# **A1 in Northumberland: Morpeth to Ellingham**

**Scheme Number: TR010059**

## **Summary of Proposed Changes to Application**

<b>Regulation Reference:</b>	Infrastructure Planning (Examination Procedure) Rules 2010
<b>Planning Inspectorate Scheme Reference</b>	TR010059
<b>Document Reference</b>	TR010059/7.5
<b>Author:</b>	A1 in Northumberland: Morpeth to Ellingham Project Team, Highways England

## Indicative Earthwork Change Locations

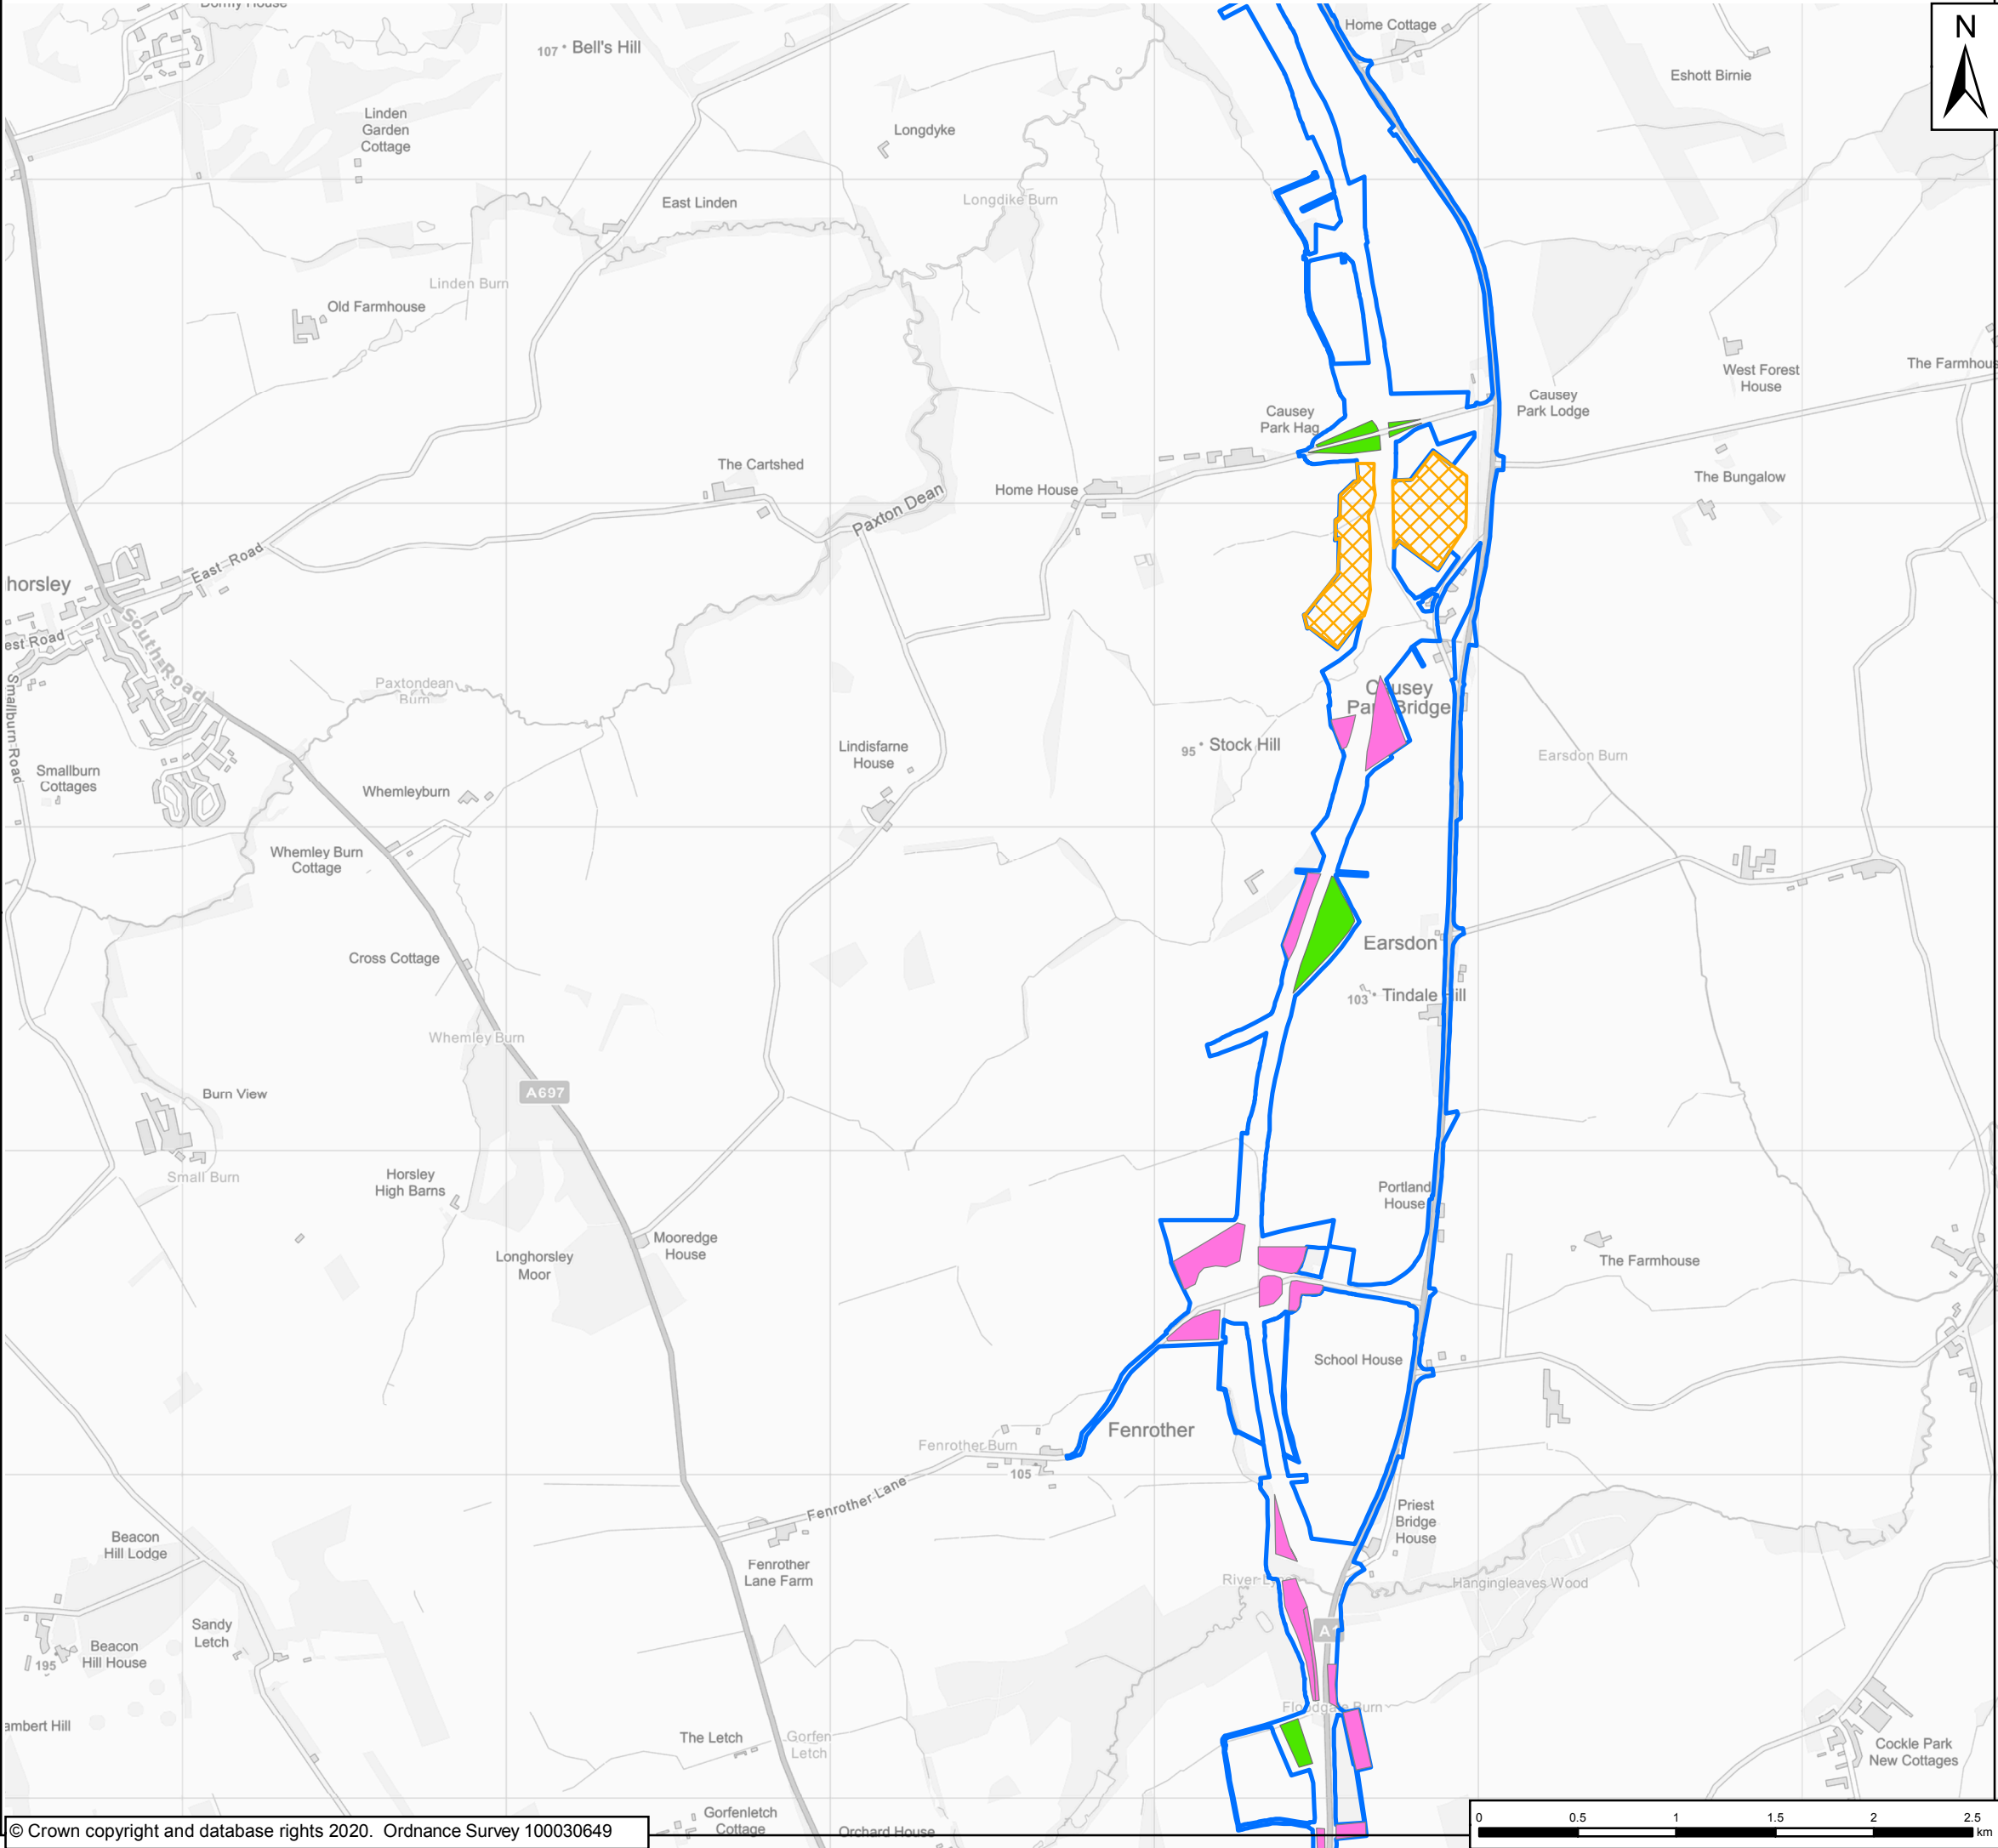
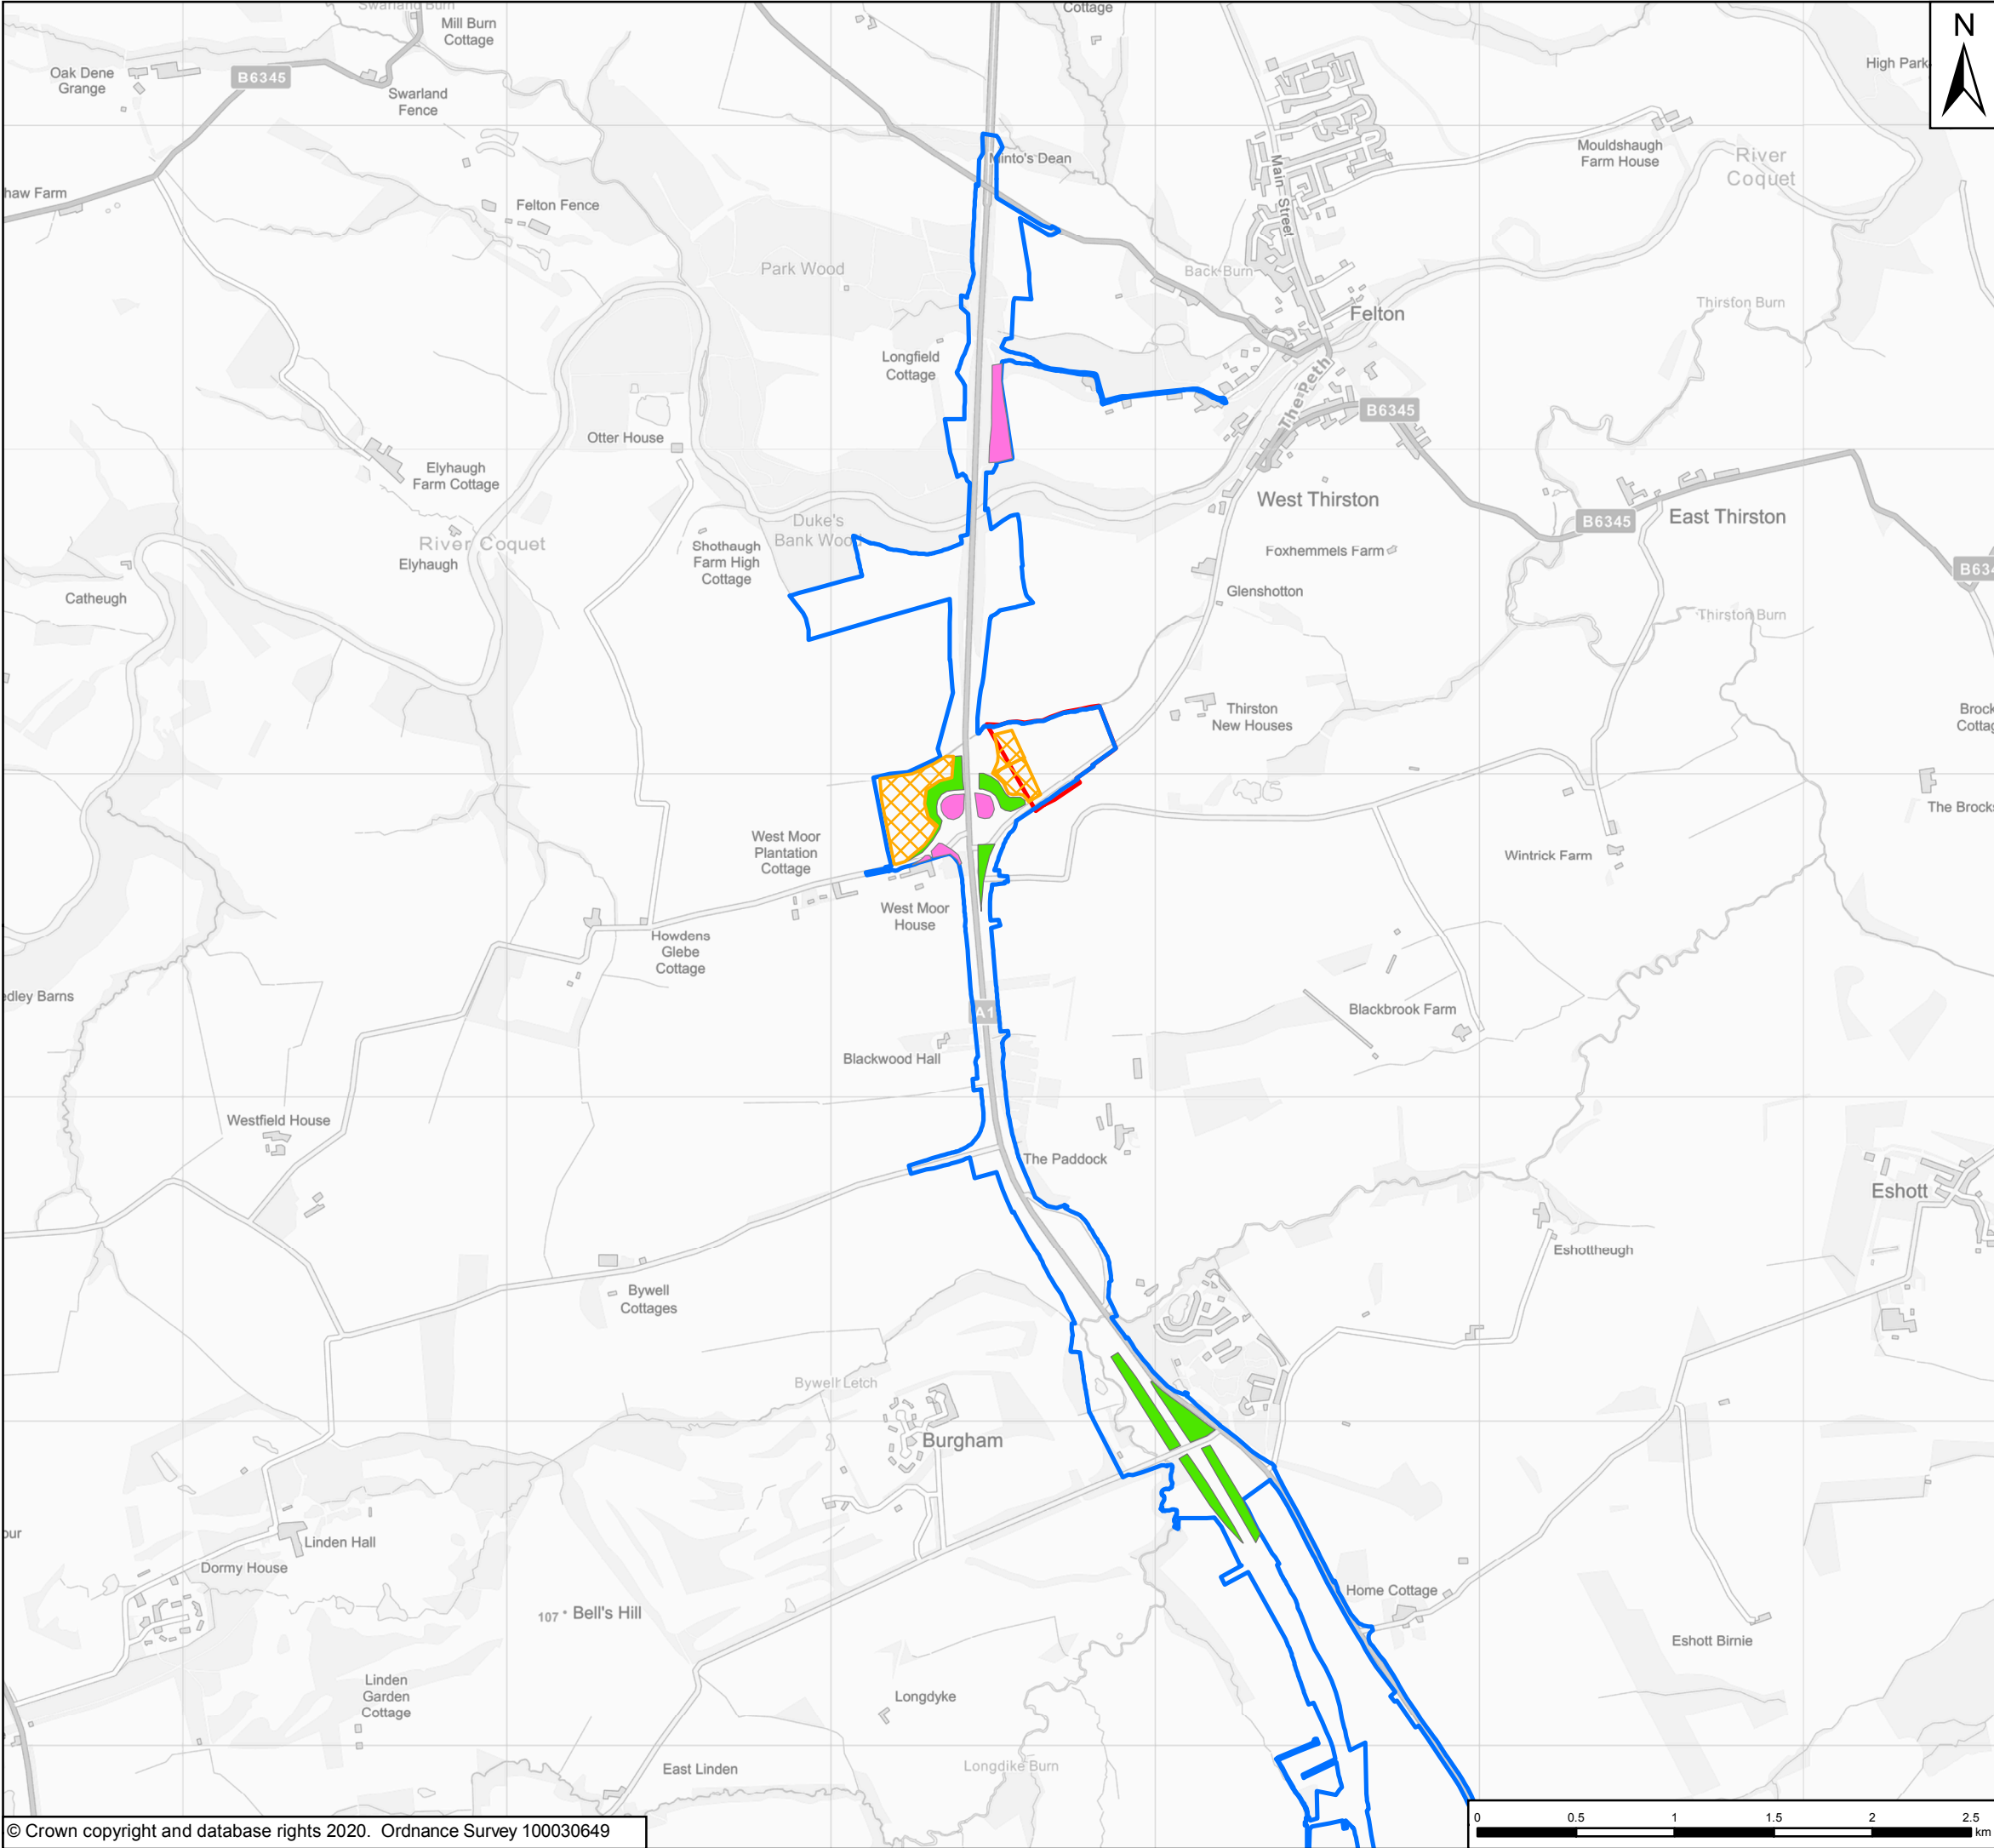
- 2.1.1 The Applicant proposes to maximise the re-use of materials (via excavation, deposition and temporary storage), within the existing Scheme extents. A recent review of the earthworks strategy has identified an opportunity to reduce earthwork movement and as a result greater flexibility in temporary and permanent storage of Site won material is required to achieve this. The indicative earthworks areas are shown in the figure in the **Indicative Earthwork Change Locations** figure in **Appendix A**.
